# Memo

To: Stephen Lines, First Mining Gold Date: August 20, 2021  
From: Derrick Moggy, Sheila Daniel Wood  
CC: Mark Ruthven, Wood  
Ref: ONS2104  
Re: Springpole Gold Project, Project Description Update

Figure 4.1.1.1

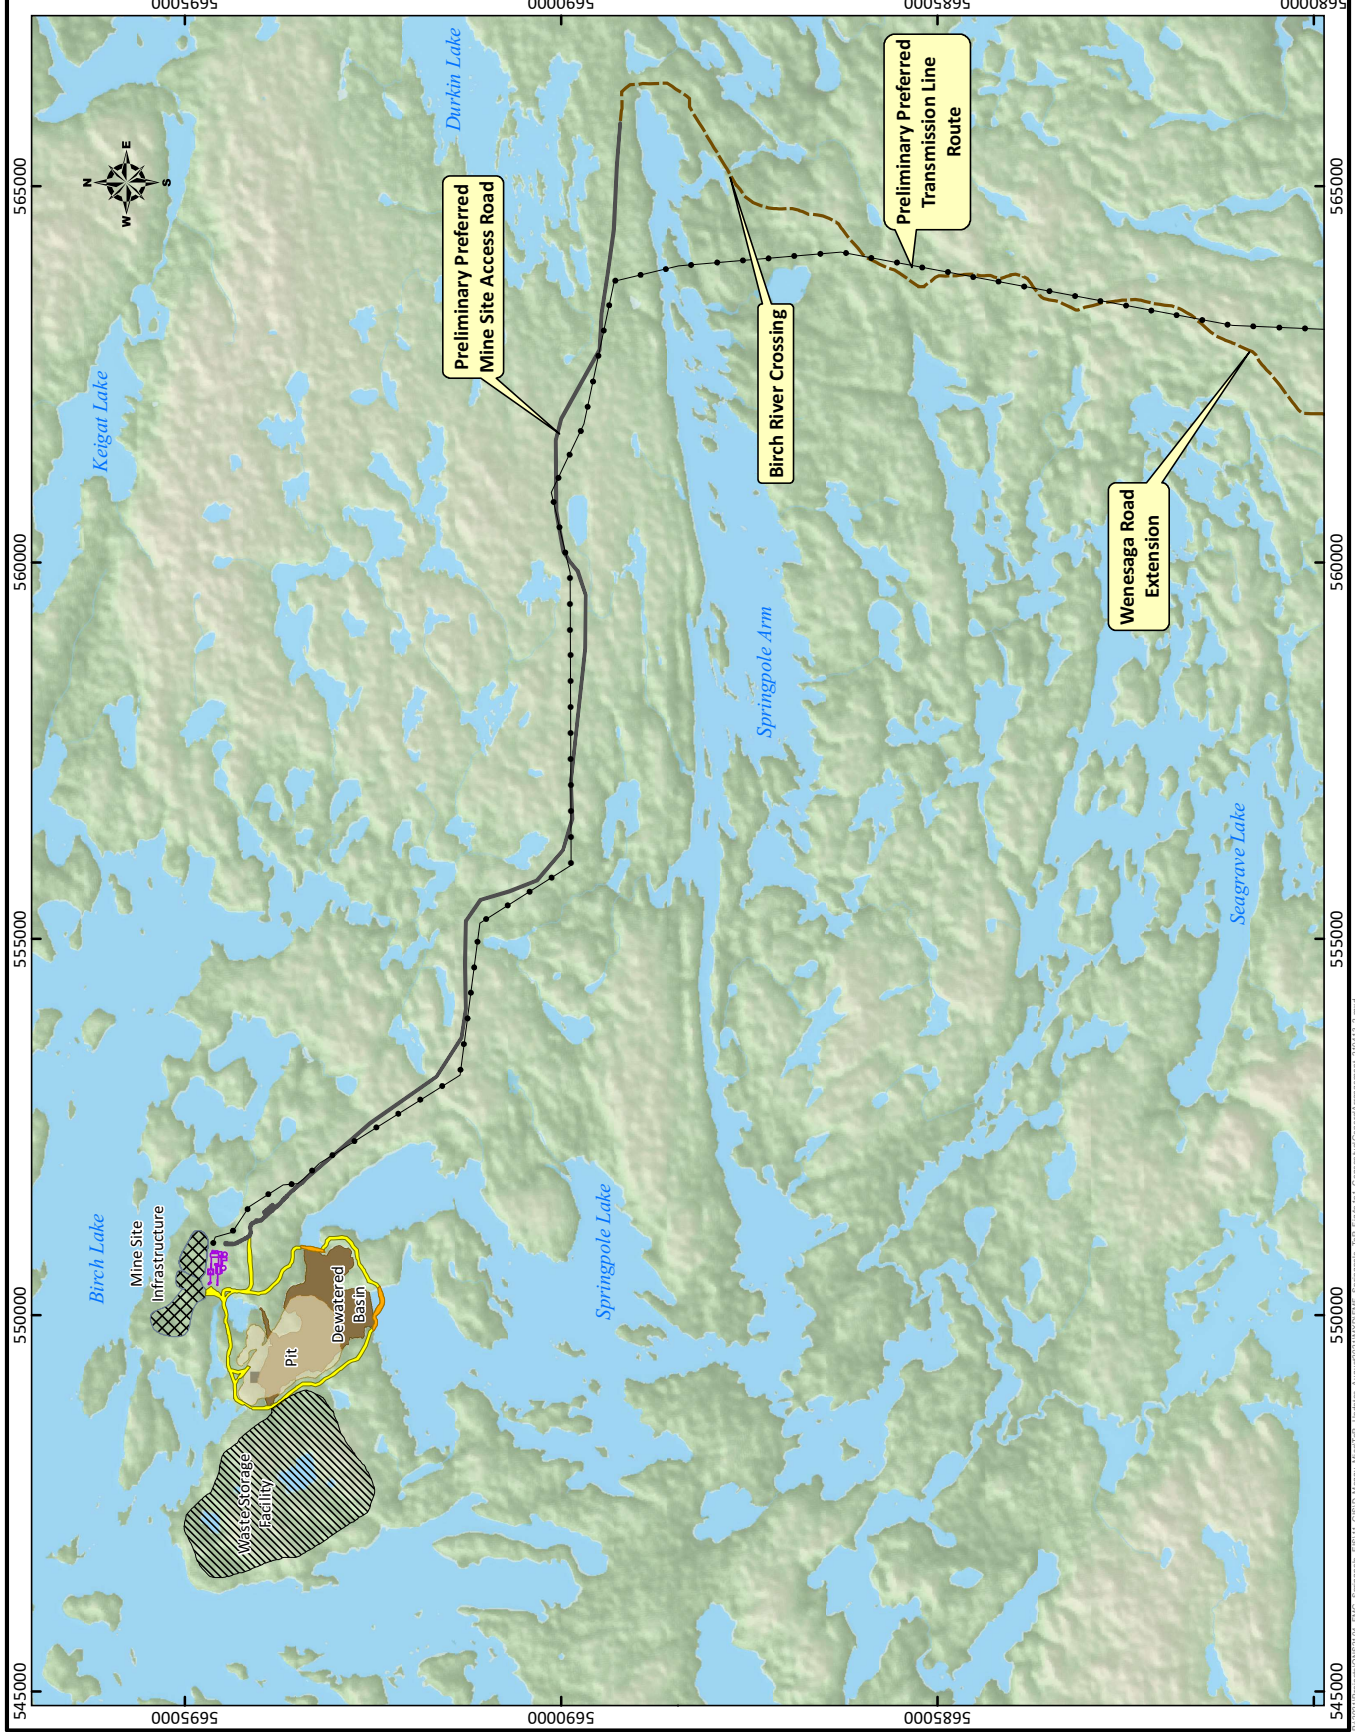
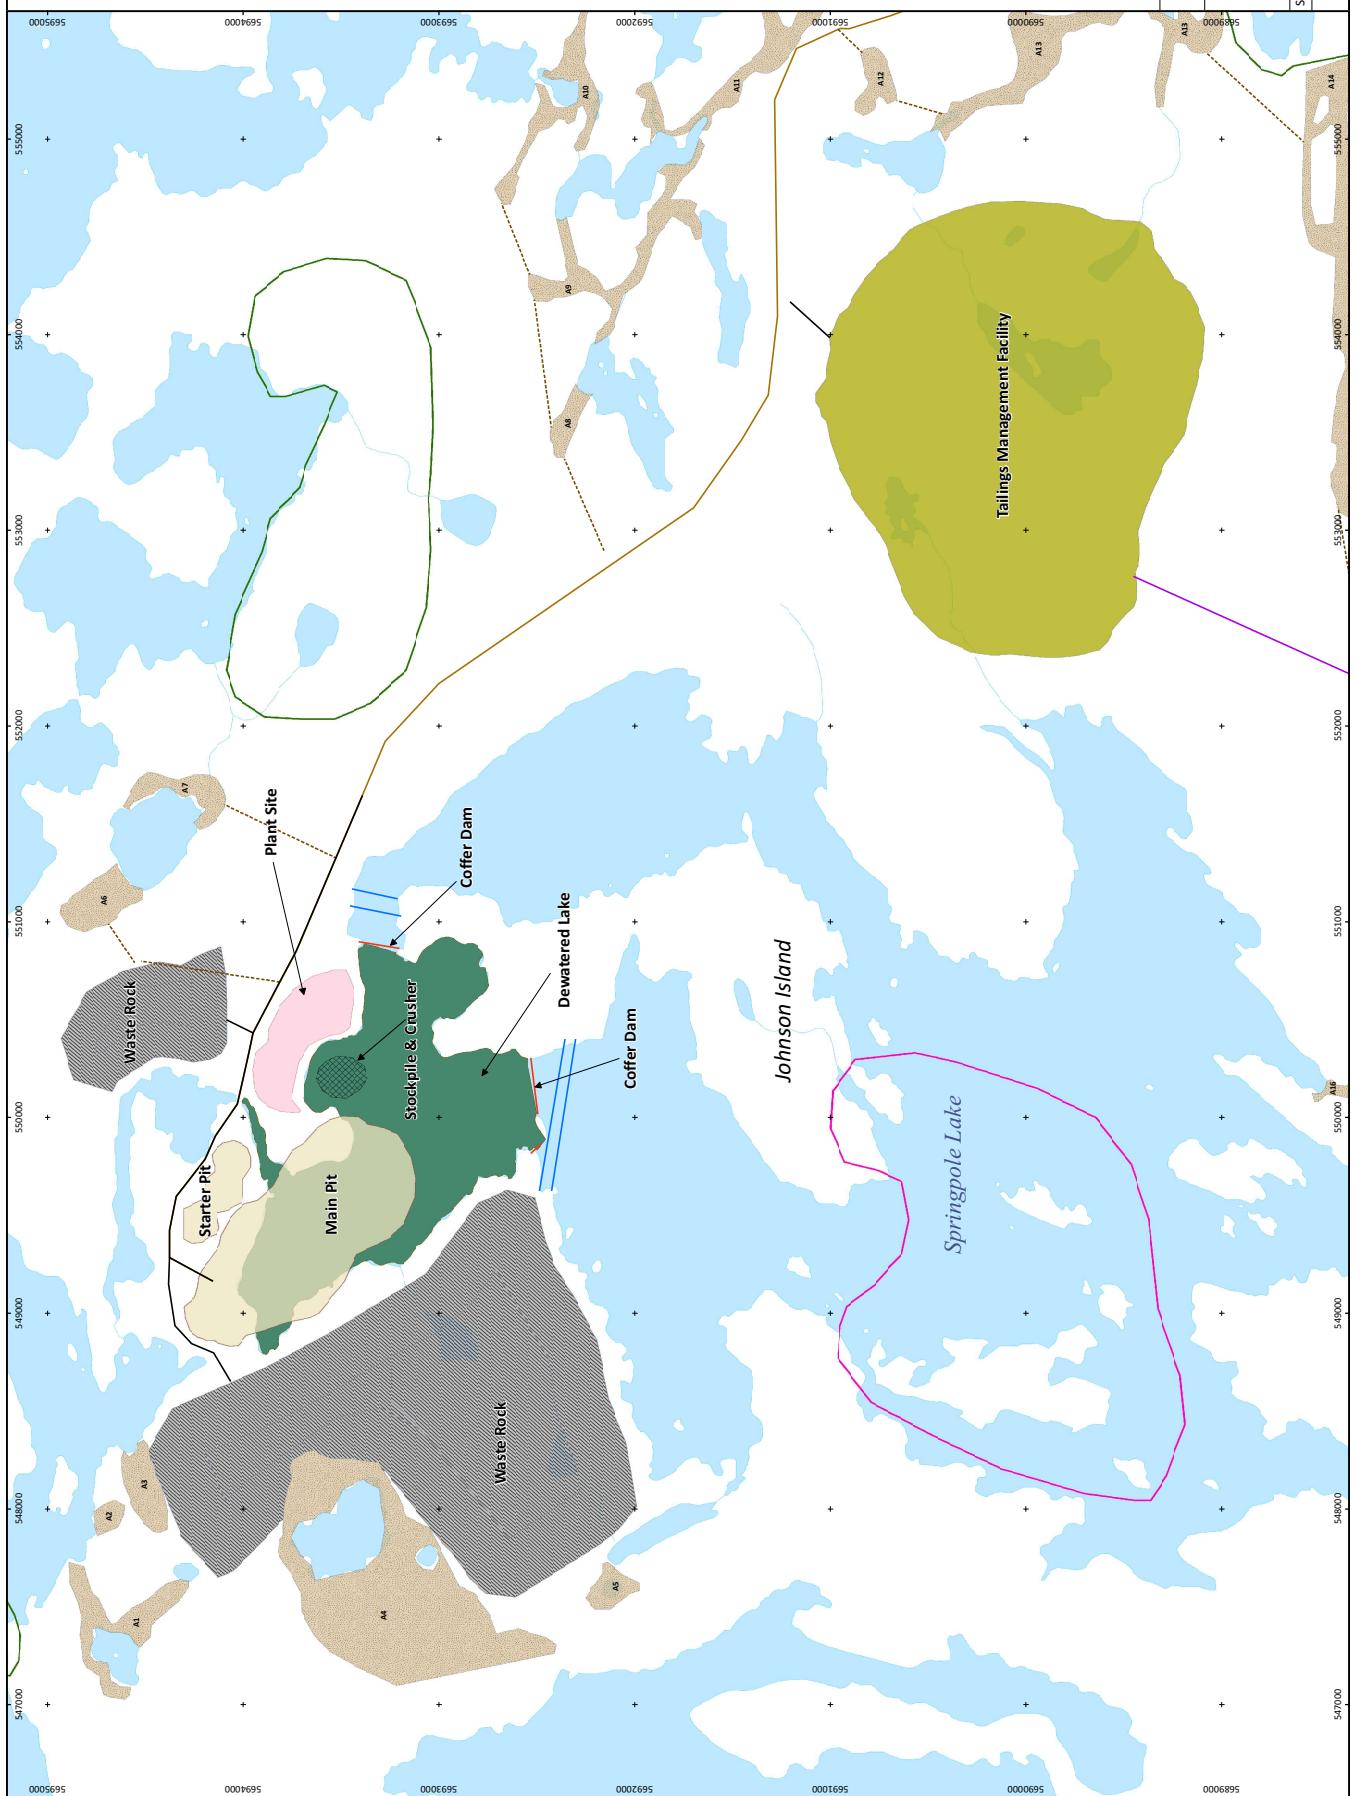
- **Cofferdams:** In reference to Section 3.1.2 of the 2018 Project Description, there has been a re-assessment of the number and length of dams required, from approximately three dams of

510 metres (m) length, to two dams of approximately 940 m total length. However, the location and orientation of the dewatering cofferdams as shown in Figures 3-2, 3-2A, 3-2B and 3-2C in the 2018 Project Description have not materially changed and continue to be representative for the Project.

- **Lake Bed Sediments Repository:** This component may be located on land rather than in the portion of dewatered lake area, to facilitate future use of the material in site reclamation as noted in Section 3.1.4 of the 2018 Project Description. However, the alternative locations noted in the 2018 Project Description for the lake bed sediment repository will be considered during the preparation of the EIS. Alternative locations outside the Springpole Lake watershed are not expected to be identified. If an alternate location is identified outside the Springpole Lake watershed and determined to be the preferred alternative, the effects to that watershed would be assessed in the EIS.

As noted in Section 3.1.6 of the 2018 Project Description, and shown in Figures 3-2, 3-2A, 3-2B, 3-2C and 3-3, a Tailings Management Facility is proposed to be located south of the mine site, and a Waste Rock Facility adjacent to the open pit. There is the potential that tailings and waste / mine rock may be co-disposed in a co-located facility. In this case, the proposed Co-disposal Facility may be located where the Waste Rock Facility is shown in the figures noted above. The southern Tailings Management Facility is anticipated to be included as an alternate location.

Approximately 76 Mm<sup>3</sup> of tailings and 102 Mm<sup>3</sup> of mine rock from the Project will require storage over the life of the mine. The Project will be designed to store this capacity and based on the ongoing engineering design, is expected to have a height of approximately 70 m and surface area of about 360 ha subject to confirmation, which is similar to the 365 ha proposed in the 2018 Project Description. The footprint of the Co-disposal Facility may be further optimized at this location and will be described in the EIS.

**Preliminary Transmission Line Corridor**

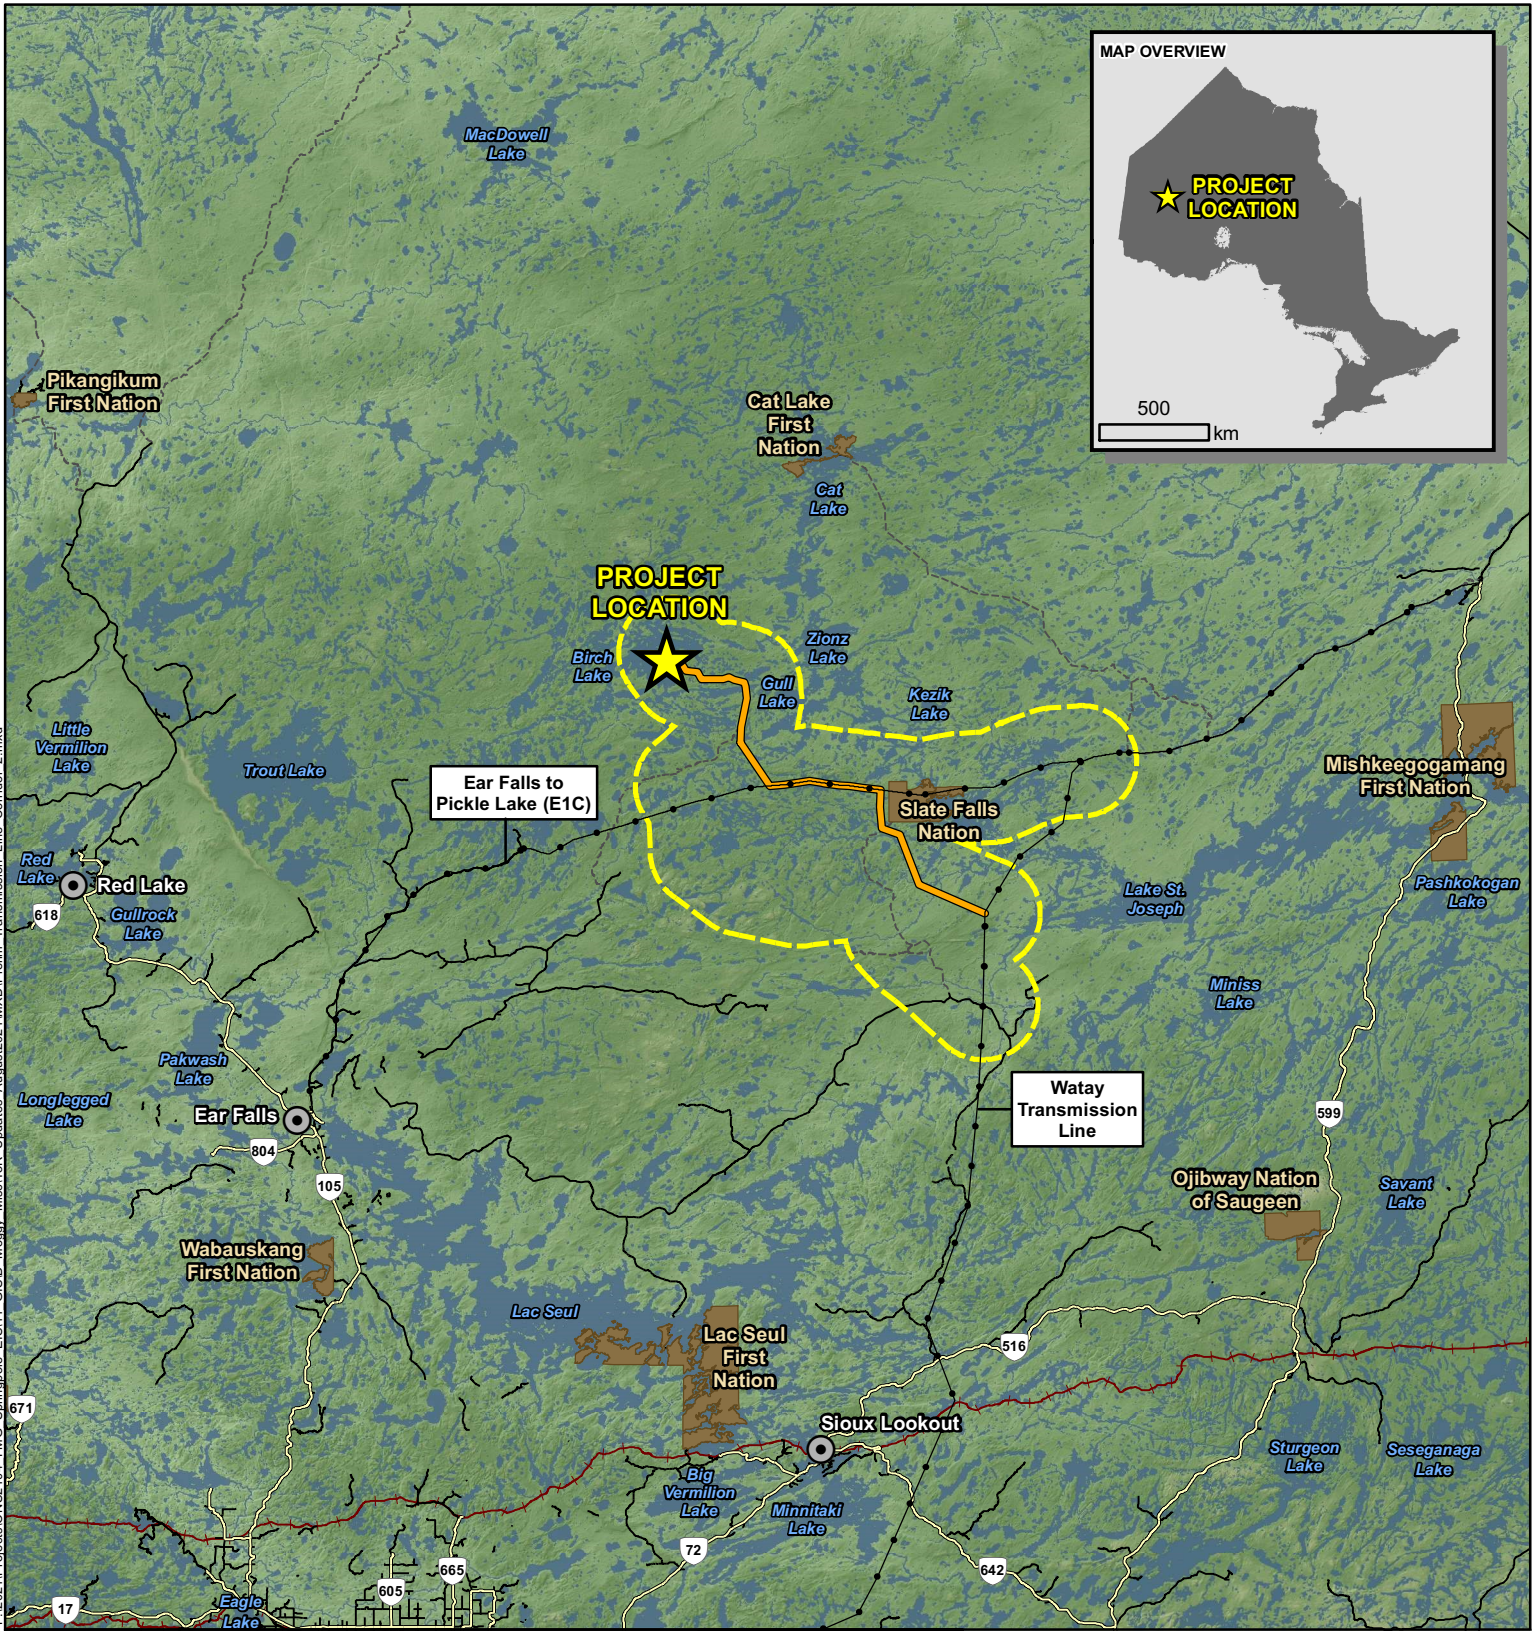
- **Transmission line:** In reference to Section 3.1.10 of the 2018 Project Description, the preferred route and voltage is still under assessment. An approximately 90 kilometre (km) long right-of-way may be constructed by FMG for the installation of a 230 kV transmission line from the Springpole Gold Project site to the corridor for the Wataynikaneyap transmission line, as shown in Appendix C. One alternative transmission corridor route being considered may be routed alongside the existing E1C transmission line and through Slate Falls Nation Reserve lands to the Wataynikaneyap Transmission Line.
